Landscape Referral Response

Application Number:	DA2022/0340
Date:	22/04/2022
Responsible Officer:	Thomas Burns
Land to be developed (Address):	Lot 361 DP 700858 , 21 Parkview Road FAIRLIGHT NSW 2094

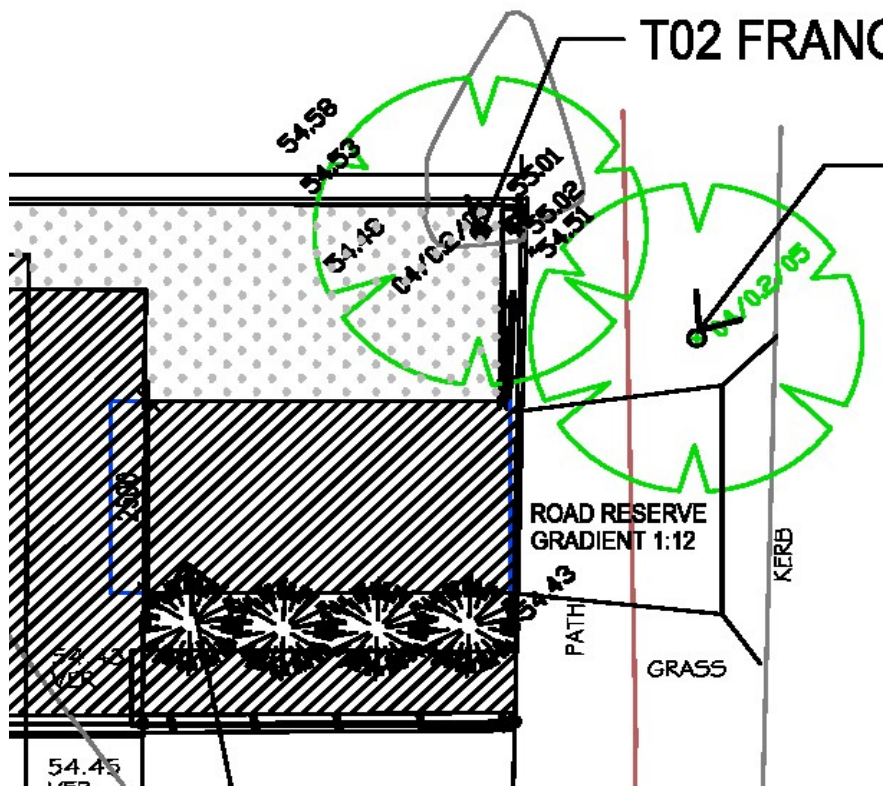
The plans indicate that the new driveway crossover is to be located adjacent to an existing street tree, though the tree is indicated for retention.

Concern is raised regarding the proximity of the crossover to the tree and it is recommended that the crossover be relocated further south of the tree and butt up to the entry path to the dwelling. This would require deletion of a small planted area indicated on the plans between the path and the drive, which seems to serve little purpose, particularly in relation to exit from a vehicle from the passenger side (if car is parked front first).

Subject to relocation of the crossover further away from the street tree, no objections are raised with regard to landscape issues subject to conditions.
